vk3pe

THESE ARE THE SCHEMATICS FOR COMBO STAR Vers "BB"

COMBO STAR

Sheet:	SCHEMATICS BY VK3PE & C.S.	
5	TITLE:- H:COMBO-SCHEMATIC-PROJECT-121109/COMBO-DSP_MBD.sch FOR PANEL	
of	16	
	"VK3PE"	Vers

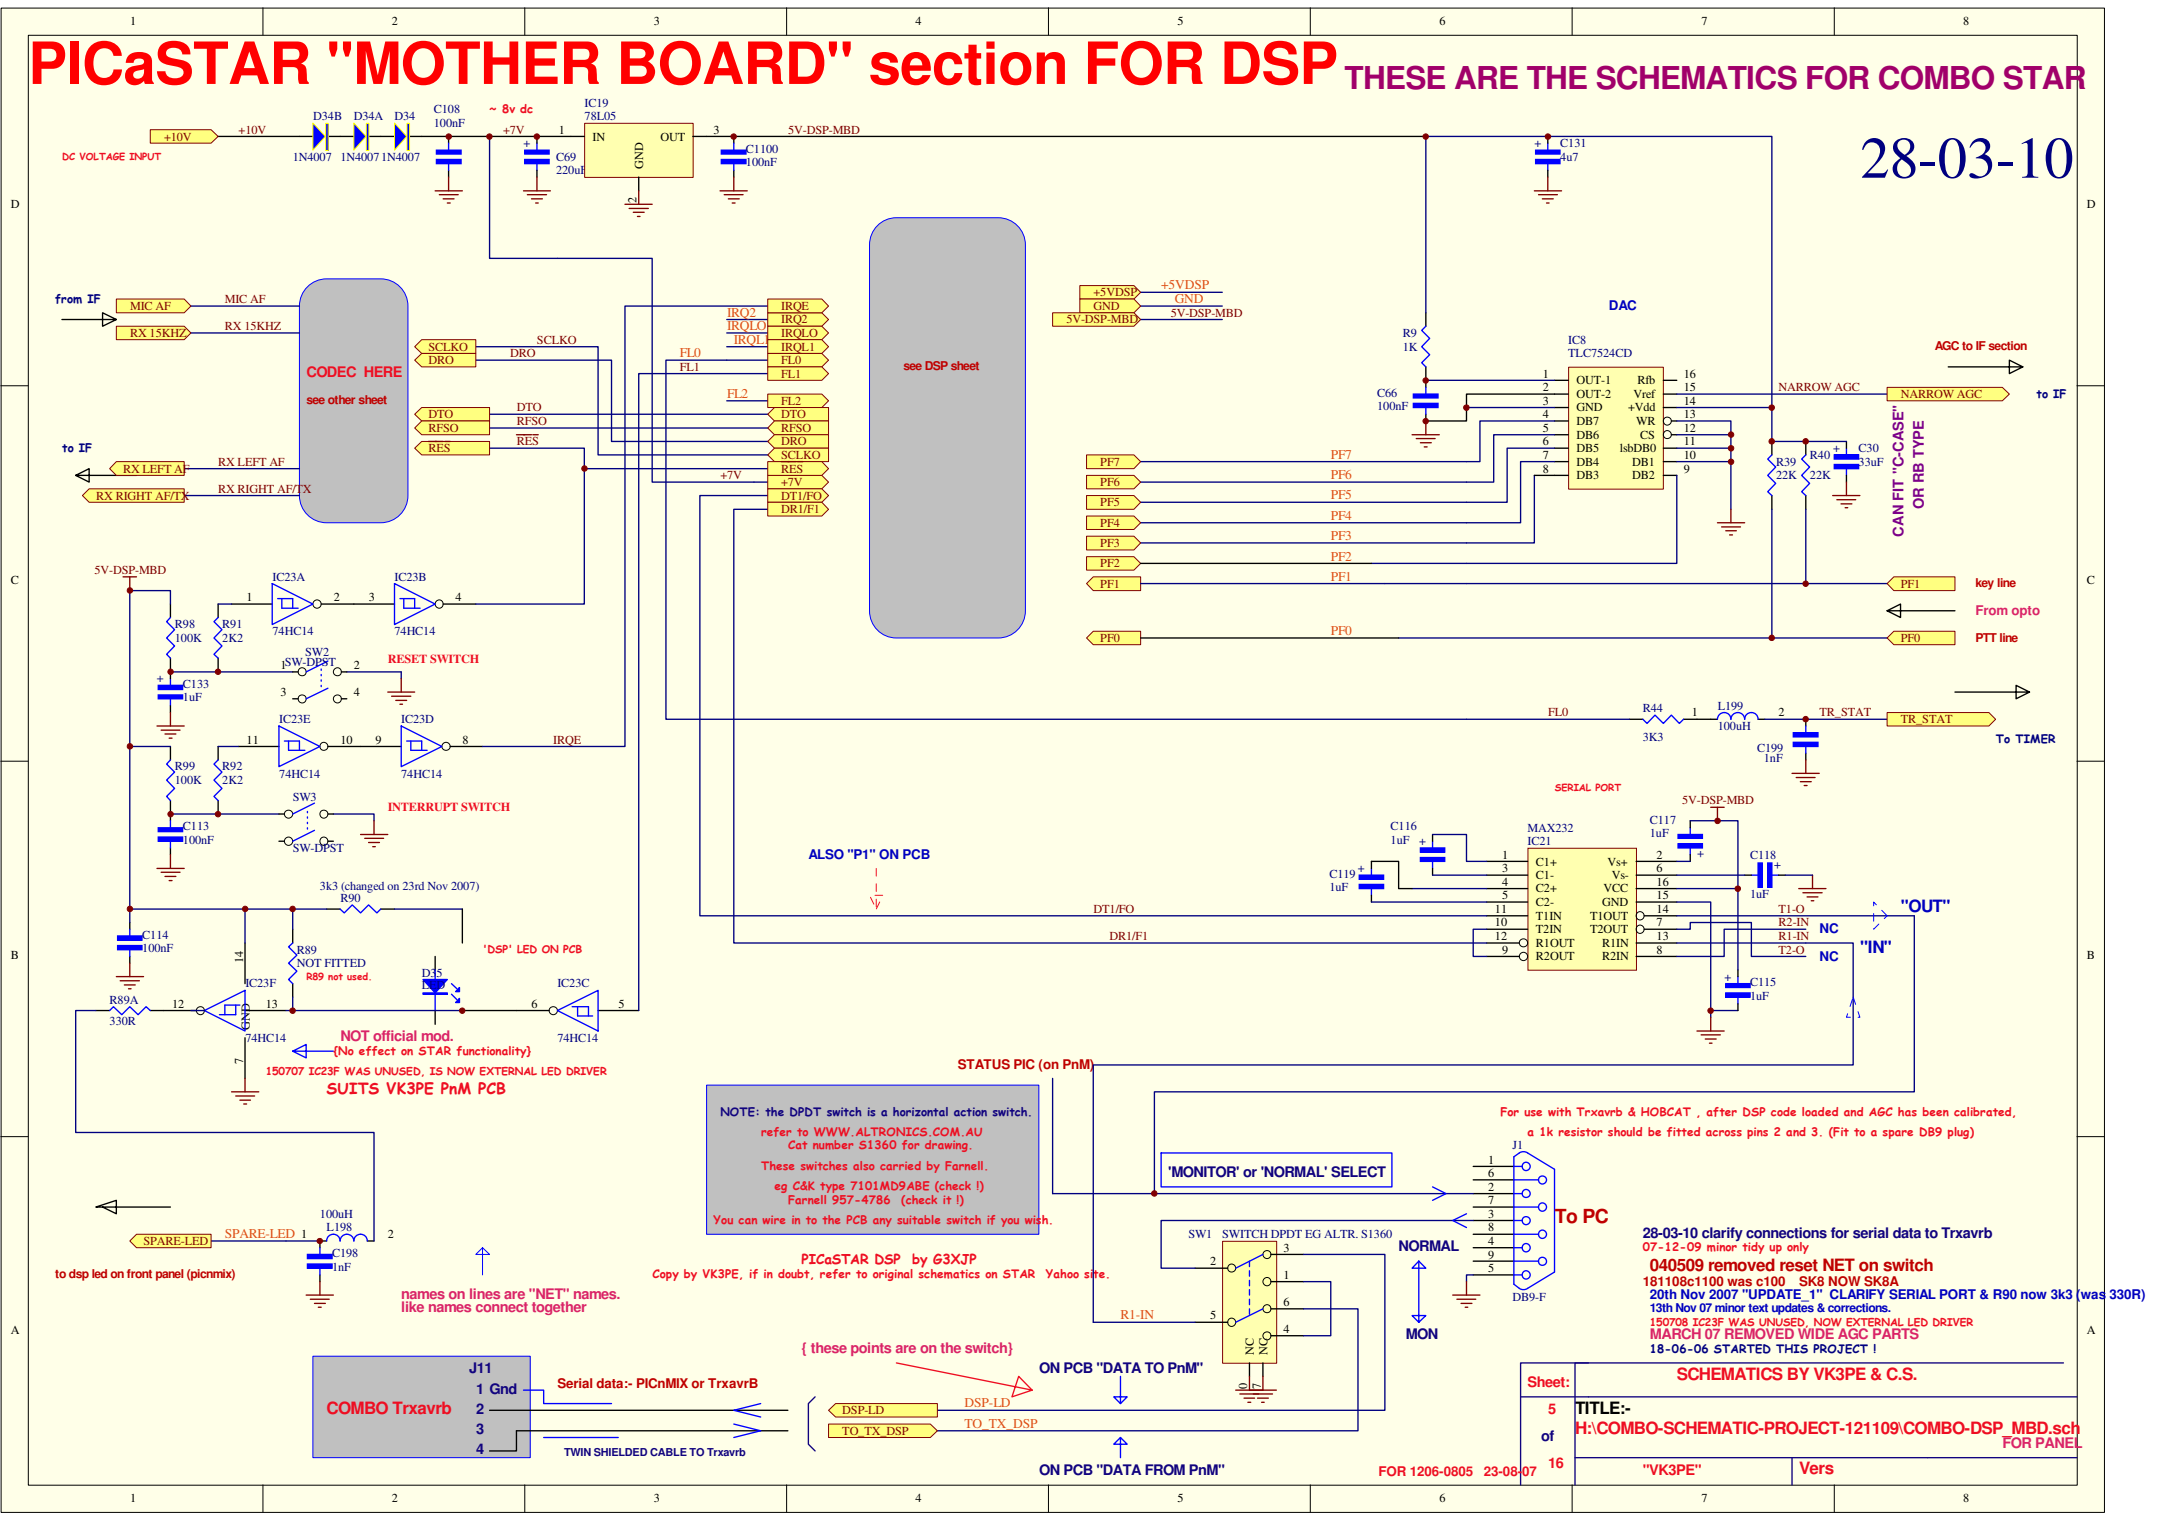
The DSP motherboard area (sheet 5) has been updated to clarify the connections from the Serial Data switch routing to the Trxavrb PCB (or PICnMIX if used) See bottom area of the sheet.

28-03-10 clarify connections for serial data to TrxavrB
07-12-09 minor tidy up only
040509 removed reset NET on switch
181108c1100 was c100 SK8 NOW SK8A
20th Nov 2007 "UPDATE_1" CLARIFY SERIAL PORT & R90 now 3k3 (was 330R)
13th Nov 07 minor text updates & corrections.
150708 IC23F WAS UNUSED, NOW EXTERNAL LED DRIVER
MARCH 07 REMOVED WIDE AGC PARTS
18-06-06 STARTED THIS PROJECT!

Sheet:	SCHEMATICS BY VK3PE & C.S.	
5	TITLE:-	
of	E:\COMBO-SCHEMATIC-PROJECT-121109\COMBO-DSP_MBD.sch	
16	"VK3PE"	Vers

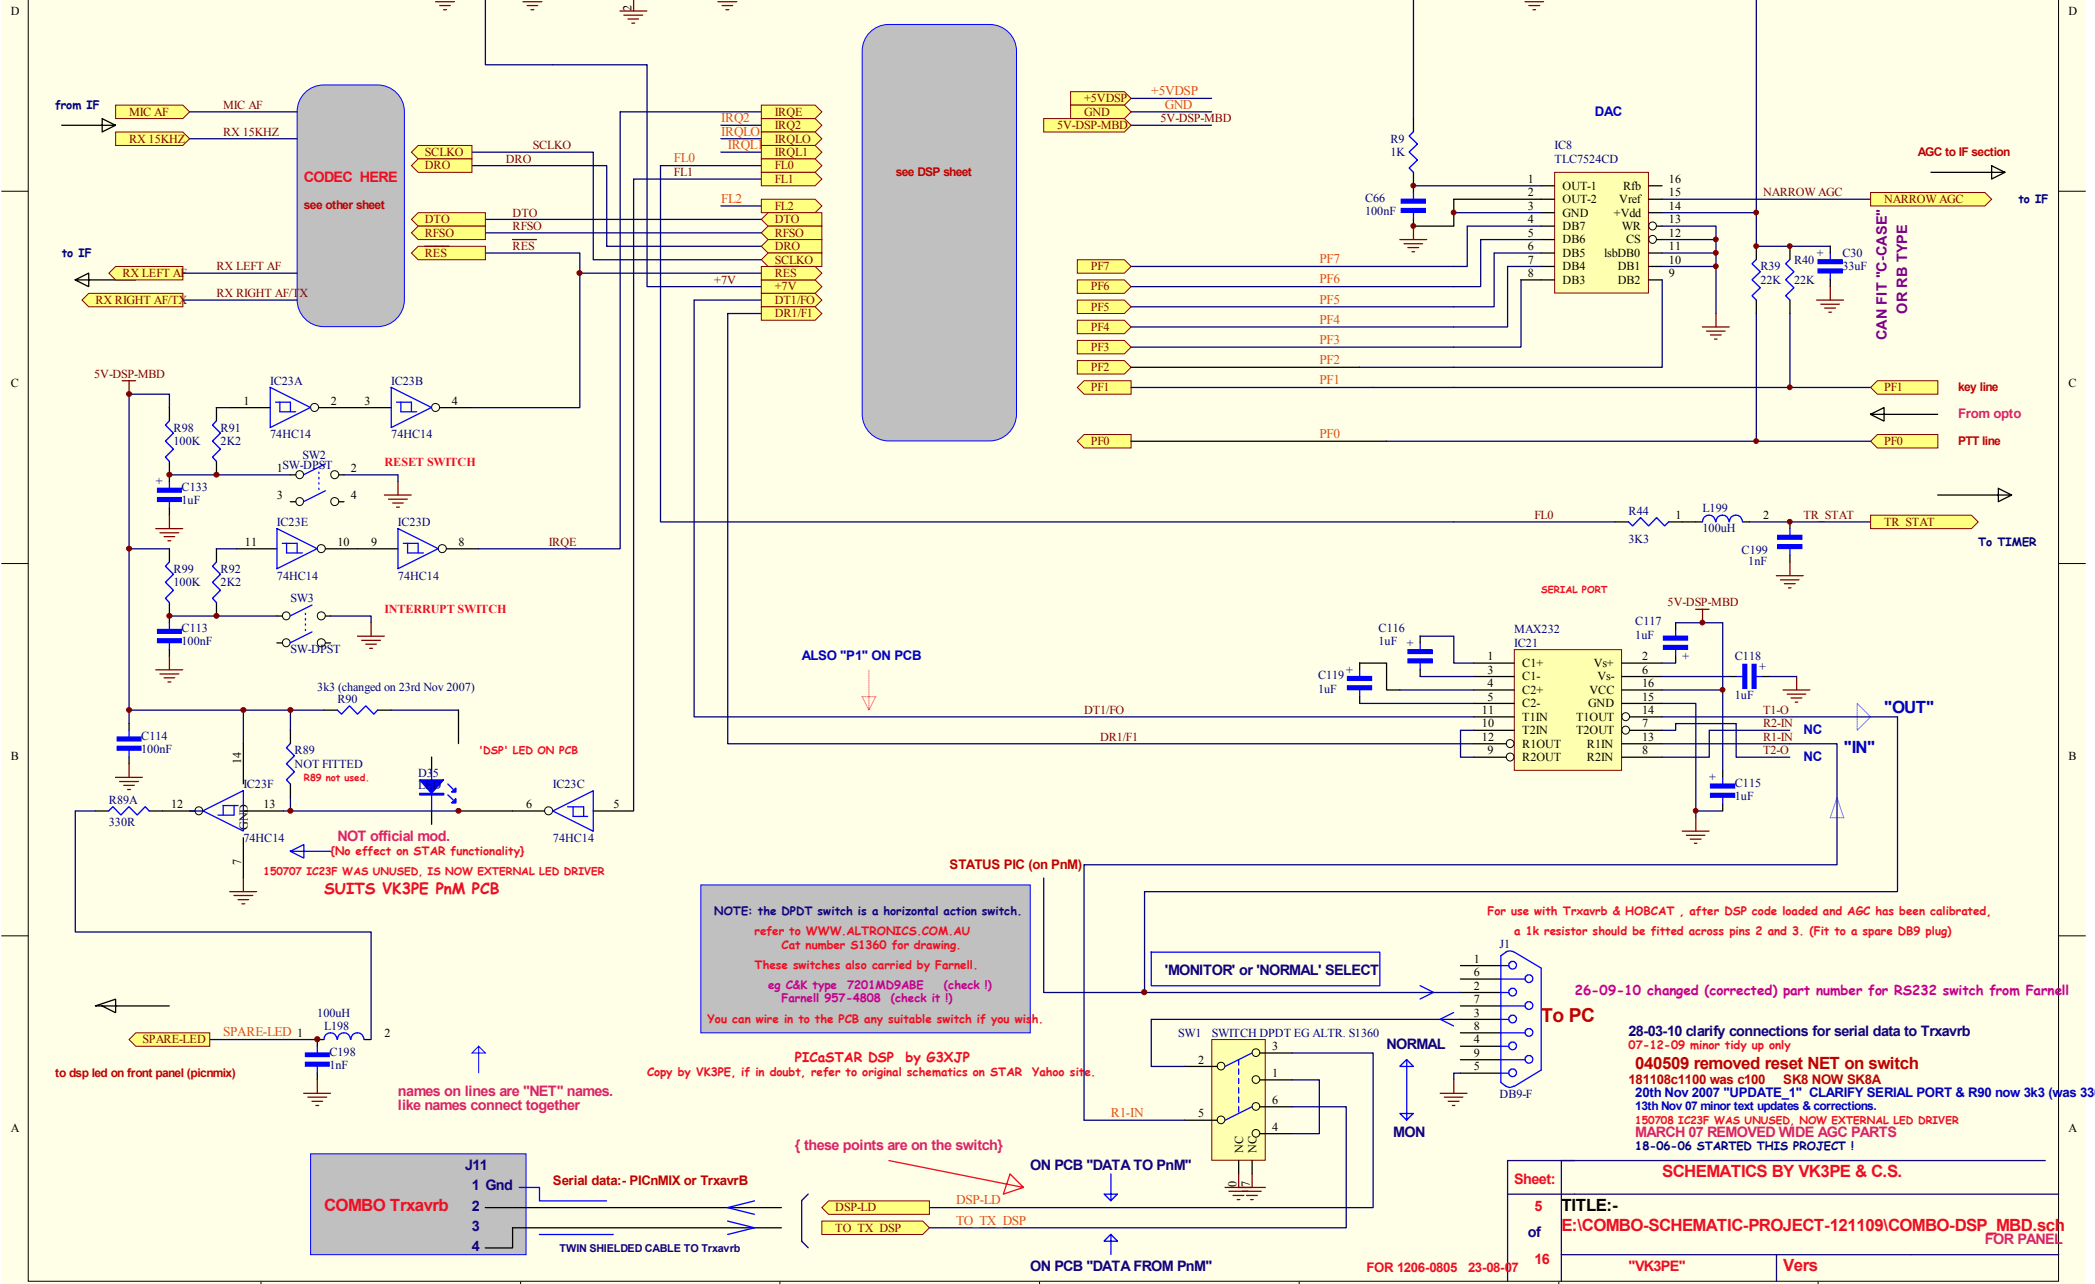
DSP motherboard, (sheet 5) The RS232 switch Farnell part number has been corrected. Please verify all numbers given in these documents though by checking Data sheets etc.

26-09-10 changed (corrected) part number for RS232 switch from Farnell

Sheet:	8
of	16
TITLE:-	COMBO SCHEMATIC FOR PICaSTAR MAGIC ROUNDABOUT
File:	COMBO-MR.sch
Vers	Ver A panel

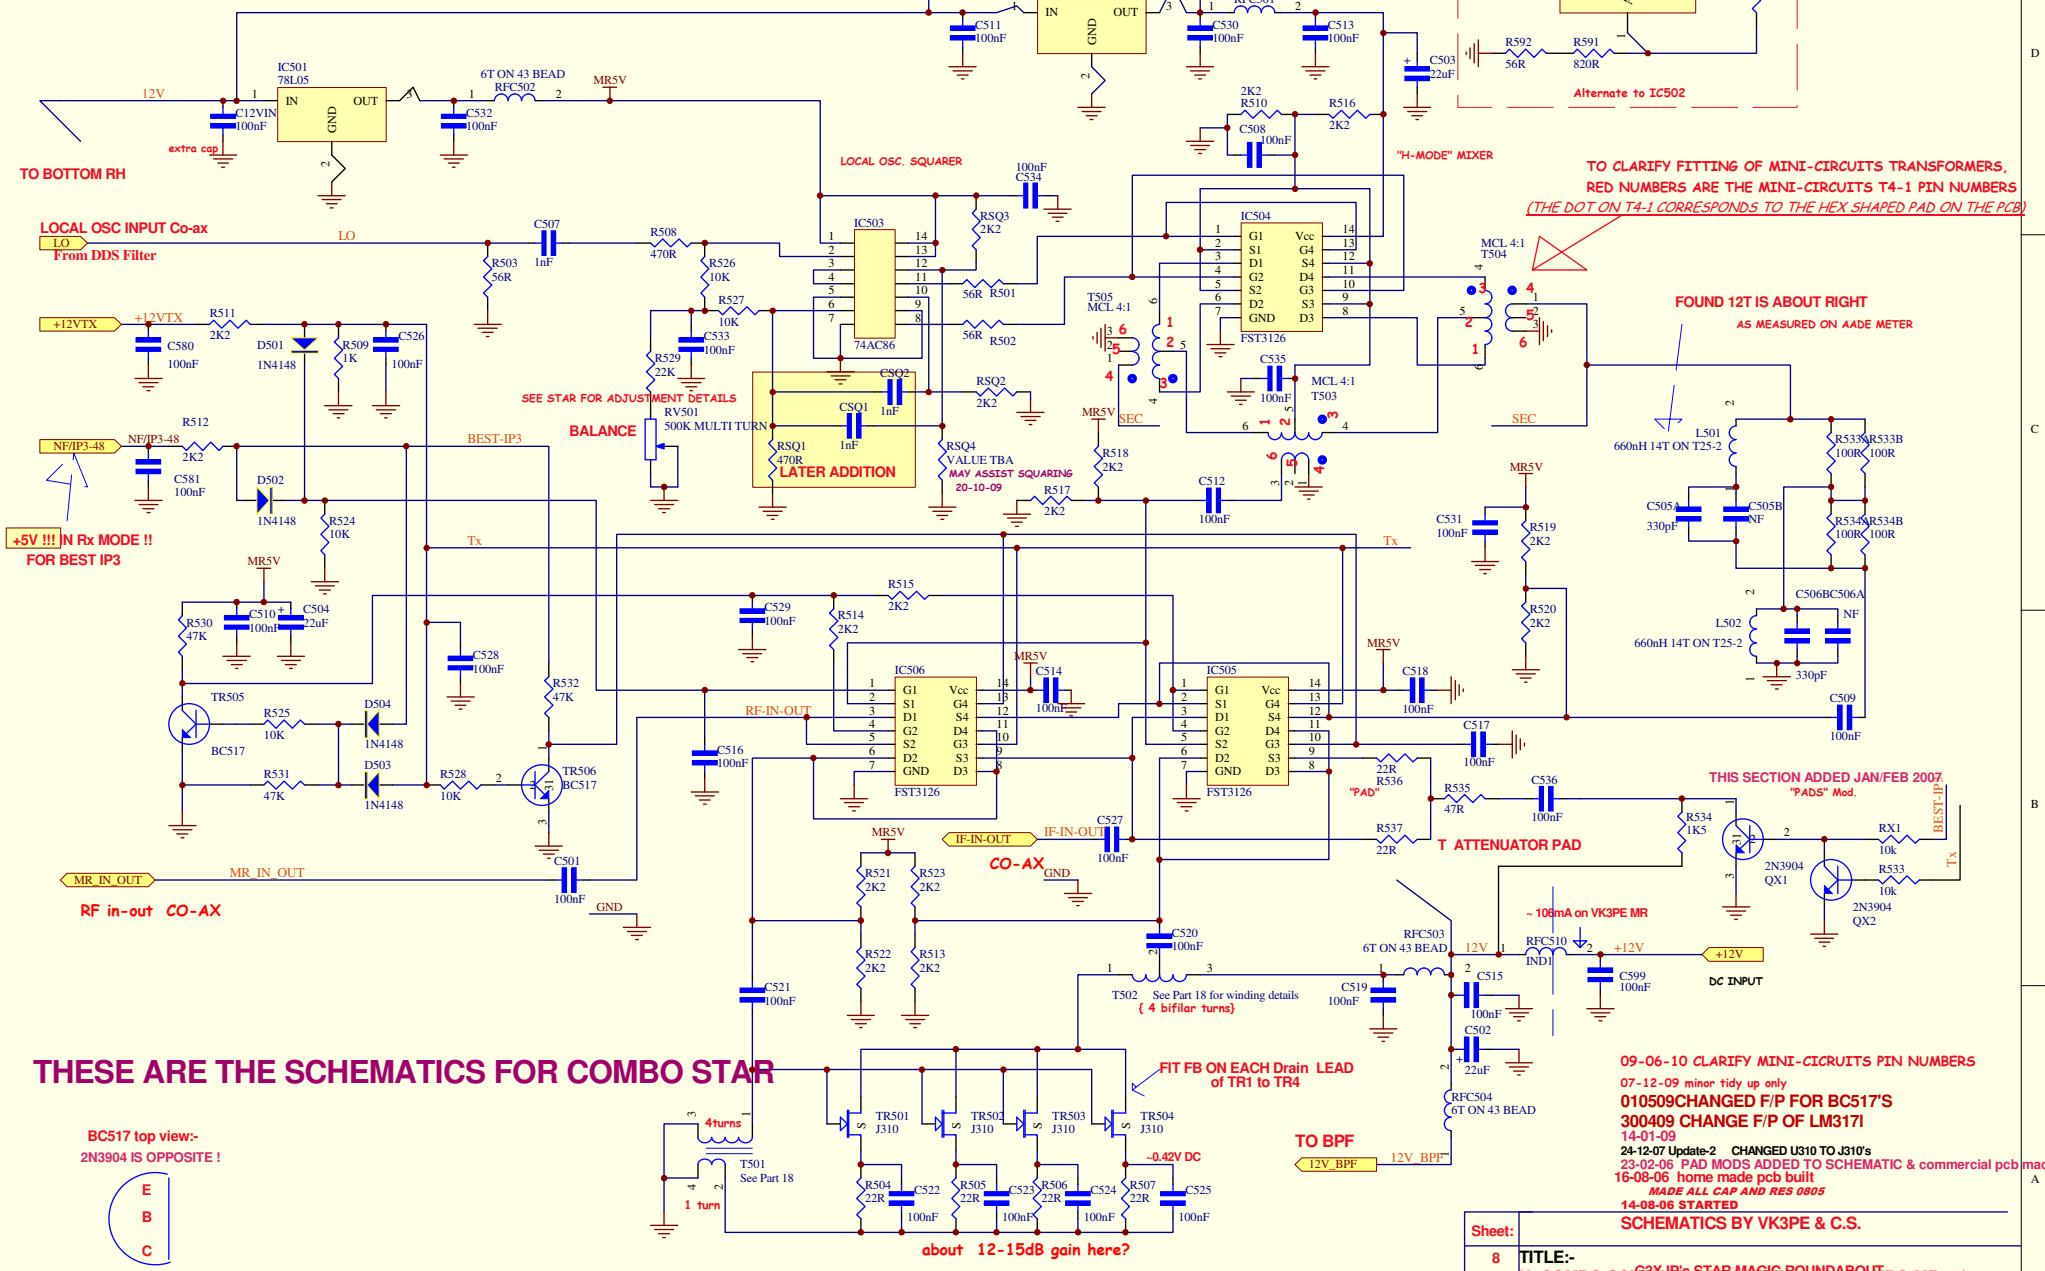
Clarified pinout of the Mini-Circuits T4-1 transformers in Magic Roundabout, sheet 8. (added pin numbers in red, of the T4-1, to the transformers. Also, a note in top right corner.)

09-06-10 CLARIFY MINI-CIRCUITS PIN NUMBERS
 07-12-09 minor tidy up only
 010509 CHANGED F/P FOR BC517'S
 300409 CHANGE F/P OF LM3171
 14-01-08
 24-12-07 Update-2 CHANGED U310 TO J310's
 23-02-06 PAD MODS ADDED TO SCHEMATIC & commercial pcb made
 16-08-06 home made pcb built
 MADE ALL CAP AND RES 0805
 14-08-06 STARTED
 SCHEMATICS BY VK3PE & C.S.
